PL2023-162

Tailormade
Landing
Preliminary
Development
Plan

Tailormade
Landing
Preliminary
Development
Plan

City Council – October 10, 2023

Architectural Elevations

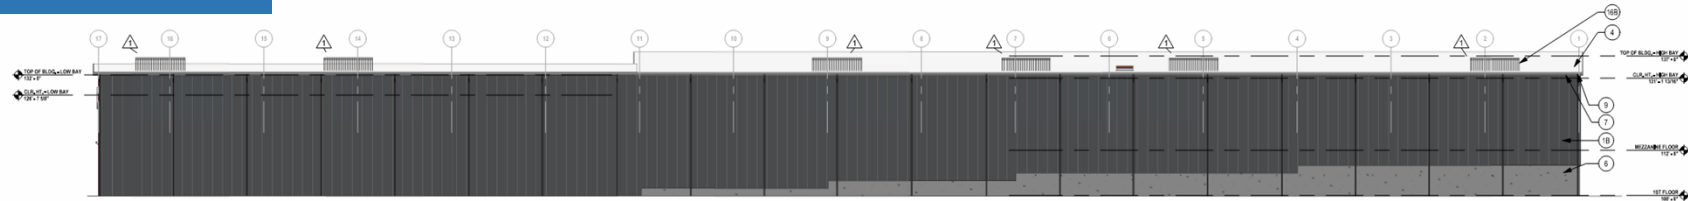
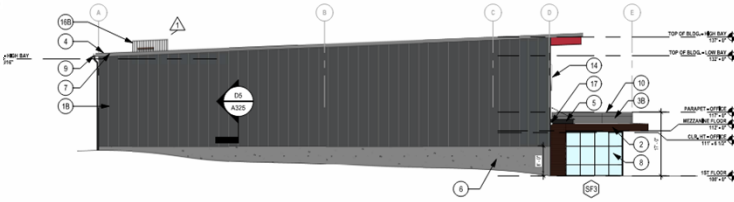
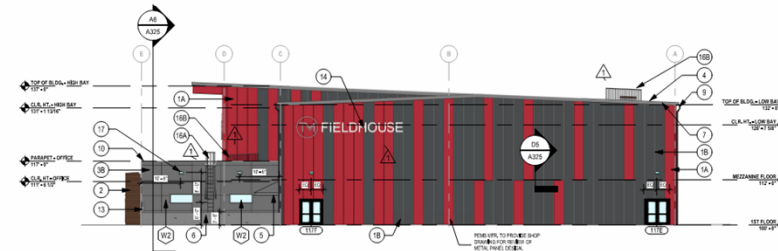
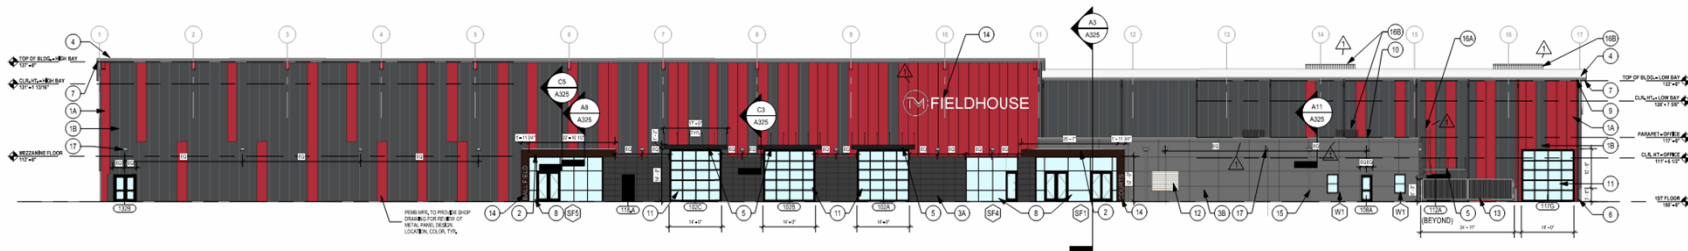
All roof-mounted equipment shall be screened entirely from view by using parapet walls at the same height as the mechanical units.

The applicant has proposed to utilize bolt on screening in the place of a parapet wall.

1. A modification shall be granted to the requirement that all roof-mounted equipment be screened entirely from view by using parapet walls at the same height as the mechanical units, to allow the proposed screening system in lieu of parapet walls for screening around the periphery of the roof-top mechanical equipment as depicted on the submitted Building Elevations, dated May 2, 2023 and revised June 21, 2023.

5. The use of architectural metal panels shall be allowed as a conditional material as depicted on the building elevations May 2, 2023 and revised June 21, 2023.

Modifications Request

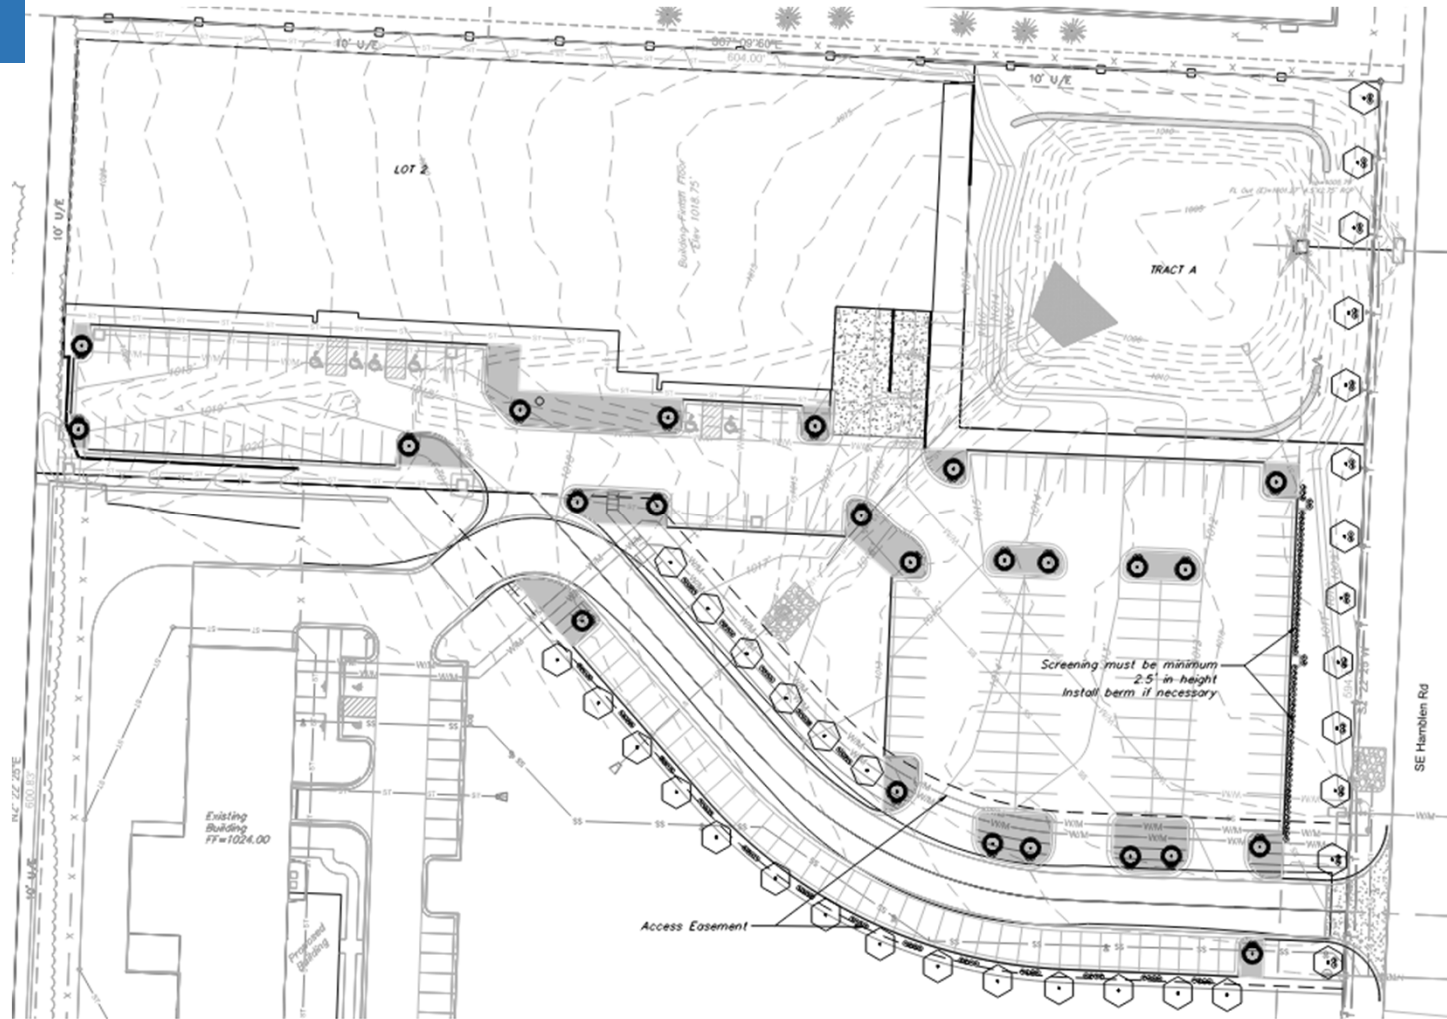
Head-in parking from any public right-of-way or private street shall not be permitted.

The applicant has requested the use of head-in parking along the private street servicing the proposed project.

2. A modification shall be granted to the requirement that head-in parking from any public right-of-way or private street shall not be permitted, to allow for head-in parking along the private street as depicted on the Preliminary Development Plan, dated June 22, 2023 and revised July 18, 2023.
